SERVICE BULLETIN No. 005LG-32-1

LANDING GEAR - EXTENSION AND RETRACTION - CONTROL AND INTERFACE

DOWNLOCK INDICATOR LAMPS - IMPROVED POWER SUPPLY ISOLATION

Figure 1 Control PCB - Additional Resistors and Links

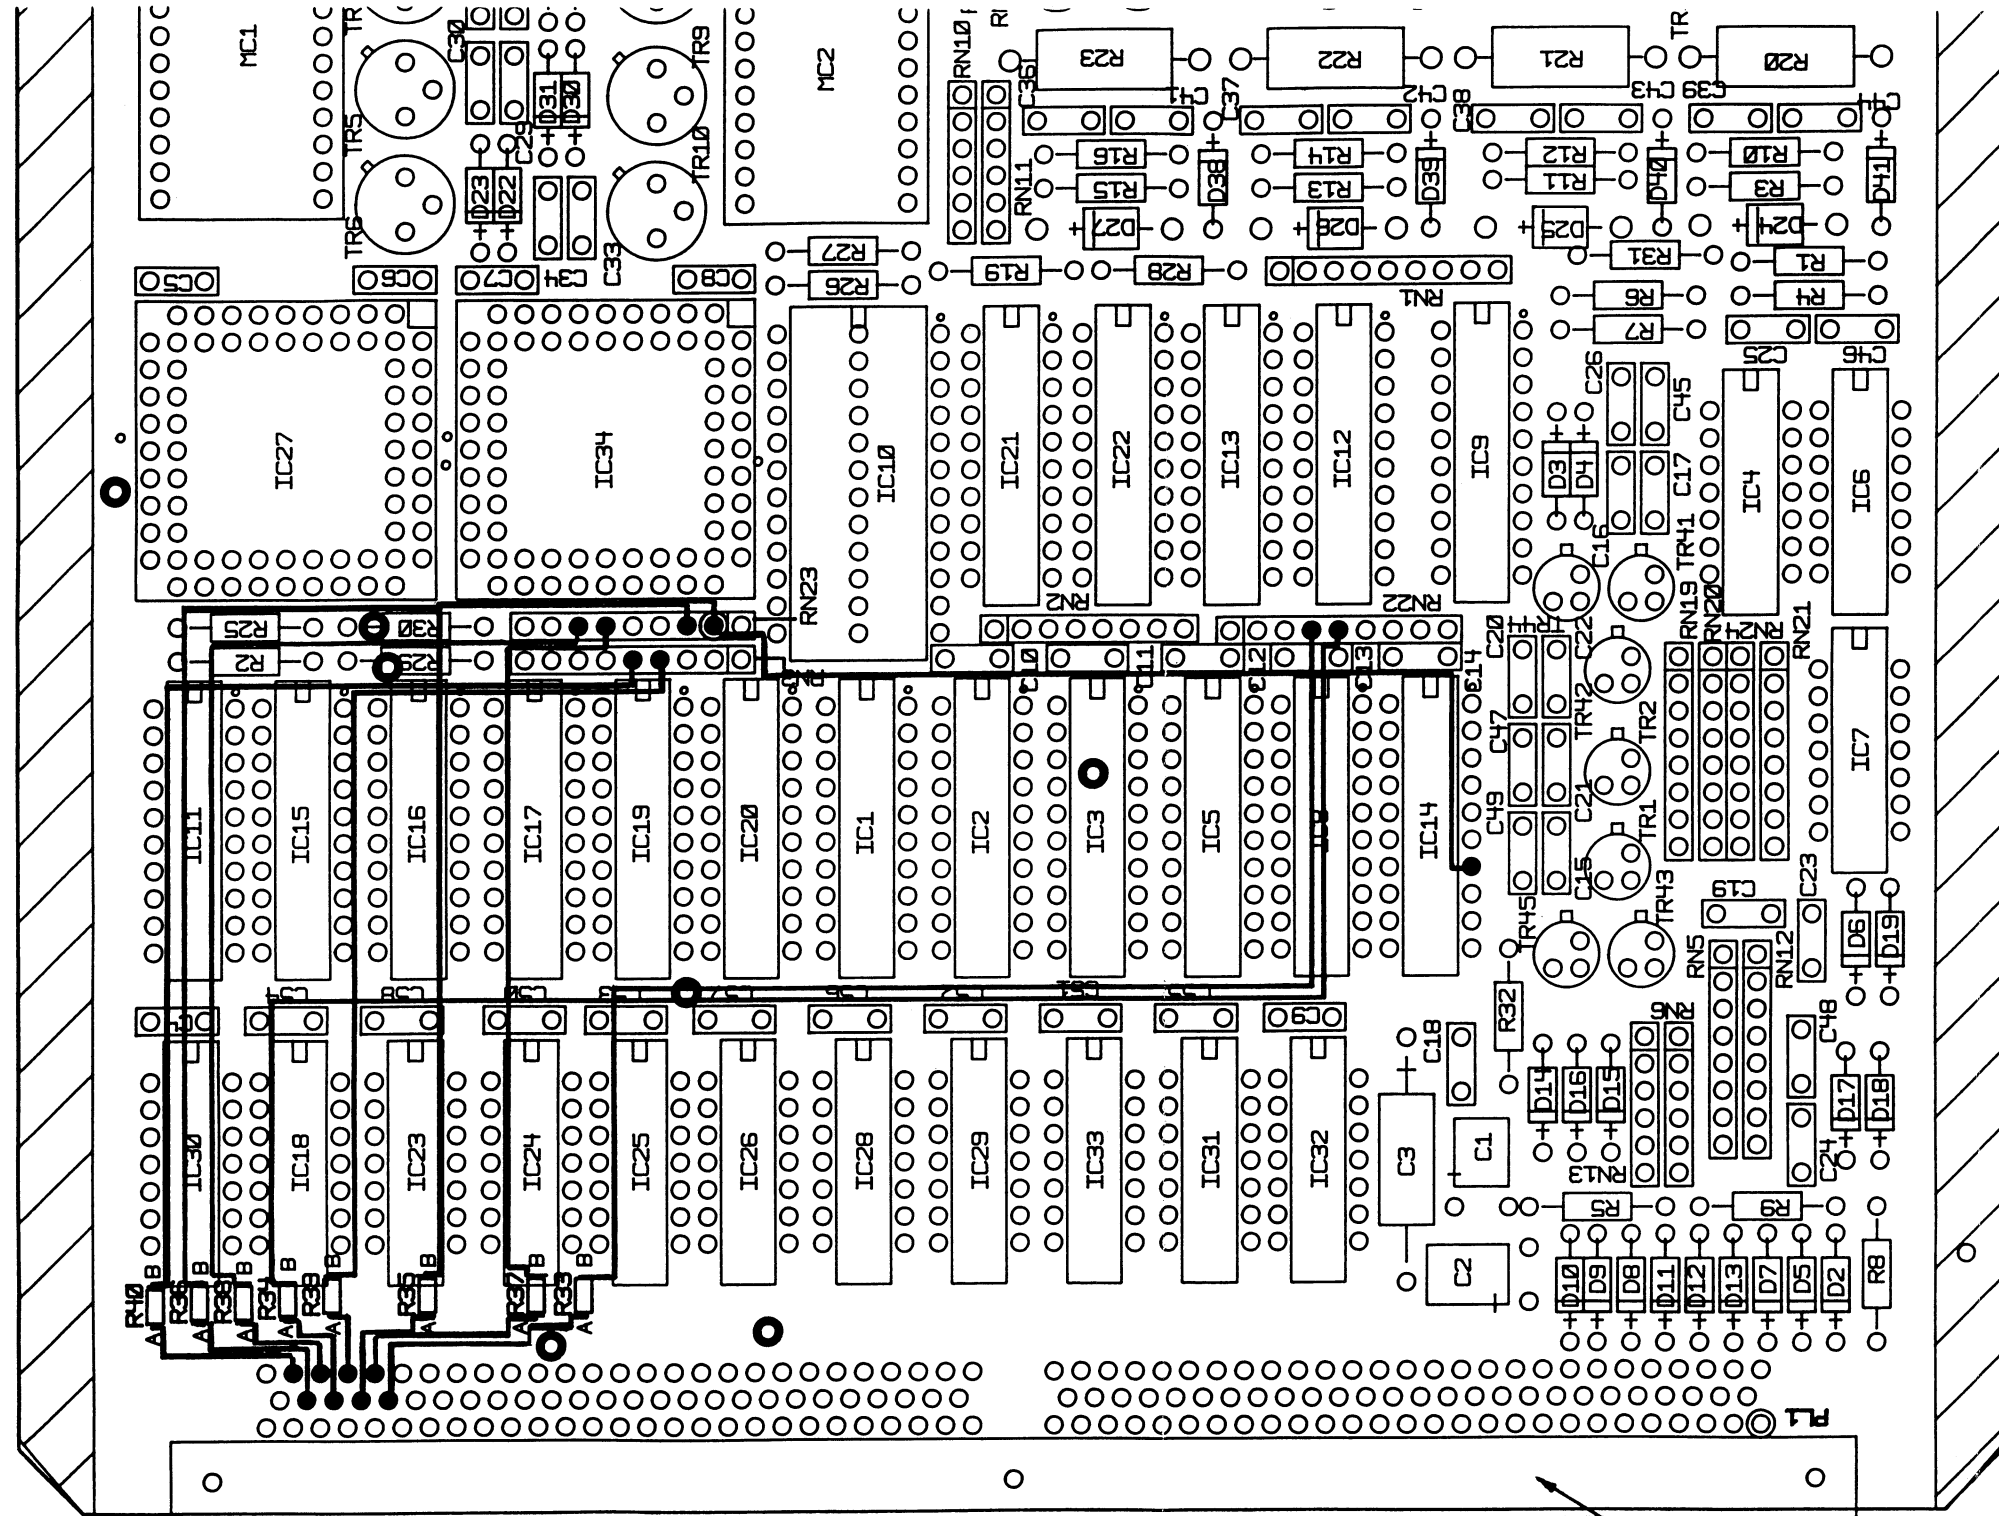
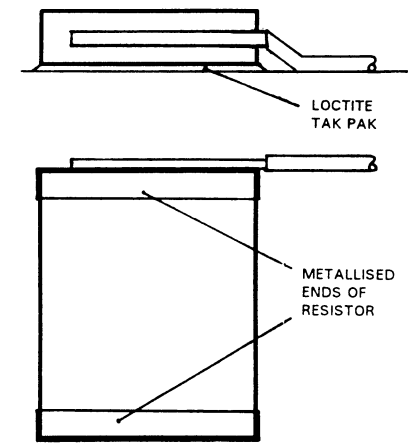
This Service Bulletin introduces the precautionary addition of eight resistors on the Control PCB (Pt. No. 005LG00-0350). The extra resistance thus introduced restores sufficient isolation between the normal and the independent supplies and circuits.

- (1) Refer to Fig. 1 at the end of this Service Bulletin and compare this illustration with the unmodified Control PCB.
- (2) Note that the eight resistors, R33 thru R40, and all the wire links, are fitted on the solder side of the PCB.
- (3) Locate the seven VIA holes (shown as ● on Fig. 1) and identify the corresponding locations on the PCB.
- (4) Locate the solder pad in position 2 of RN23 (shown as ● on Fig. 1) and identify the same pad on the PCB.
- (5) Locate the solder pads to which the wire links will be soldered (shown as ● on Fig. 1) and identify the same pads on the PCB.

- (1) Select a sharp 1.5mm diameter PCB drill.
- (2) Drill out the seven VIA holes (shown as ● on Fig. 1).
- (3) Drill out the solder pad in position 2 of RN23 (shown as ● on Fig. 1).
- (4) Using a dry, clean air blast, remove all cutting swarf from the work areas.
- (5) Using an illuminated PCB-hole magnifier, make sure that all traces of the plated-through walls have been removed. Make sure that no dirt or swarf remains inside the drilled-out holes.

- (1) Turn the PCB so that the solder side is uppermost.
- (2) Refer to Fig. 1 in this Service Bulletin. You will see that the routing of the wire links does not go over the solder pads. You must follow the same routing when you fit the links.
- (3) There are eight resistors to be added to the PCB and these are fitted on the solder side of the PCB in the positions shown in Fig. 1. The resistors and the wire links are bonded to the PCB using Loctite adhesive Tak Pak 382. Fit the resistors first and the wire links second.

NOTE: Solder the links to the metallised sides of the resistors as shown in Fig. 1. Use a surface-mount soldering iron with a controlled tip temperature between 240°C and 300 °C. The diameter of the tip must not exceed 1.5mm and the solder wire diameter must be 26SWG or less.

FROM	TO	FROM	TO
PL1/147	R33A	R33B	RN22/4
PL1/153	R34A	R34B	RN22/5
PL1/150	R35A	R35B	RN23/2
PL1/156	R36A	R36B	RN23/3
PL1/148	R37A	R37B	RN23/6
PL1/154	R38A	R38B	RN23/7
PL1/151	R39A	R39B	RN3/4
PL1/157	R40A	R40B	RN3/5
IC14/7	RN23/2
